CH05 Chiller and AFA ultraCUBE Water Hose Replacement Warning

CH03 Chiller

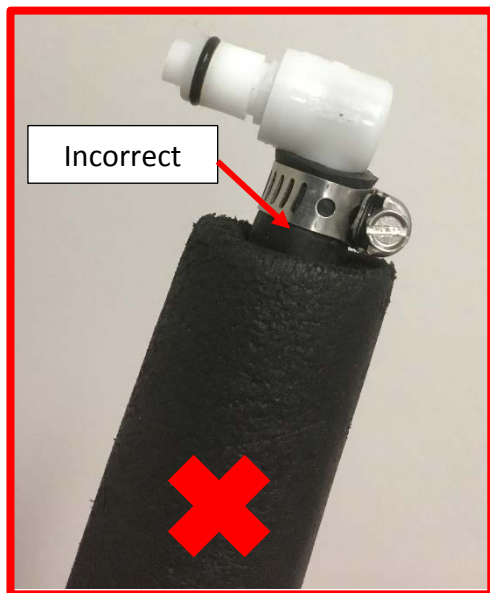
If this hose kit is part of an upgrade of existing CH03 or CH04 water chiller or WCS system the black rubber hoses previously used must be discarded and replaced with beige hoses from this kit.

Existing hose is not adequately rated for the water pressure generated by the CH05 or AFA ultraCUBE.

Remove and discard these hoses.

Install new hoses from this kit.
